Access Compliance Report Public Rights-of-Way (Curb Ramps)

Intersection ID: 27965 Main Street: BALLANTYNE_COUNTRY_CLUBrobs Street: POUND_HILL_LN Location: SW ADA ID: 1B2C359DDD74 Ramp Type: Perp Initial Pass/Fail: Fail **Overall Compliance: No Severity Score:** 1.25

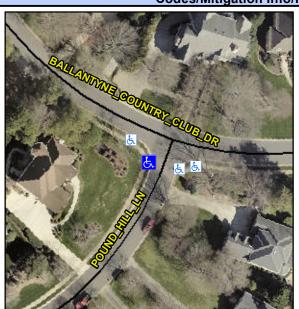
POUND HILL LN Street 1 Name Stop Condition-Street 2 StopSign Street 2 Name N/A Stop Condition-Street 1 N/A Possible Solutions: Remove & Replace Entire Ramp. Surveyor Notes: N/A PROW/ADA: Not Found, R304.5.3

Field Measurements/Component Compliance					
Compliance Description		Data	Comp	liance Description	Data
N/A	Ramp Length (in)	47.0	Yes	Ramp Slope (%)	5.3
Yes	Ramp Width (in)	48.0	No	Ramp XSlope (%)	2.5
N/A	Flare Type LT	N/A	N/A	Flare Type RT	N/A
N/A	Flare Slope LT (%)	N/A	N/A	Flare Slope RT (%)	N/A
N/A	Flare Traversable LT?	N/A	N/A	Flare Traversable RT?	N/A
N/A	Landing Length (in)	N/A	N/A	DWS Provided?	N/A
N/A	Landing Width (in)	N/A	N/A	DWS Contrast?	N/A
N/A	Landing Slope (%)	N/A	N/A	DWS Length (in)	N/A
N/A	Landing X Slope (%)	N/A	N/A	DWS Full Width?	N/A
N/A	Landing Curb? (Y/N)	N/A	N/A	DWS Offset (in)	N/A
N/A	Shared Landing?	N/A			
N/A	Gutter Ponding?	N/A	N/A	Gutter Slope (%)	N/A
N/A	Gutter Lip Ht (in)	N/A	N/A	Gutter X Slope (%)	N/A
N/A	Painted X Walk1?	No	N/A	Painted X Walk2?	N/A
	X Walk 1 Direction	To SE		X Walk 2 Direction	N/A
N/A	X Walk 1 Width (in)	N/A	N/A	X Walk 2 Width (in)	N/A
	X Walk 1 Slope (%)	2.2		X Walk 2 Slope (%)	N/A

X Walk 1 X Slope (%)	2.8		X Walk 2 X Slope (%)	N/A
N/A	Ramp inside XWalk1?	N/A	N/A	Ramp inside XWalk2?	N/A
	Road Slope (%)	N/A	N/A	Clear Space?	N/A
	Road X Slope (%)	N/A	N/A	Clear Space to XWalk (in)	N/A
N/A	Any Obstructions?	N/A	N/A	Storm Grate/Utility Hazard?	N/A
	Obstruction Type			Storm Grate/Utility Type	
		N/A			N/A
			Yes	Surface Condition? (G/P)	Good
198
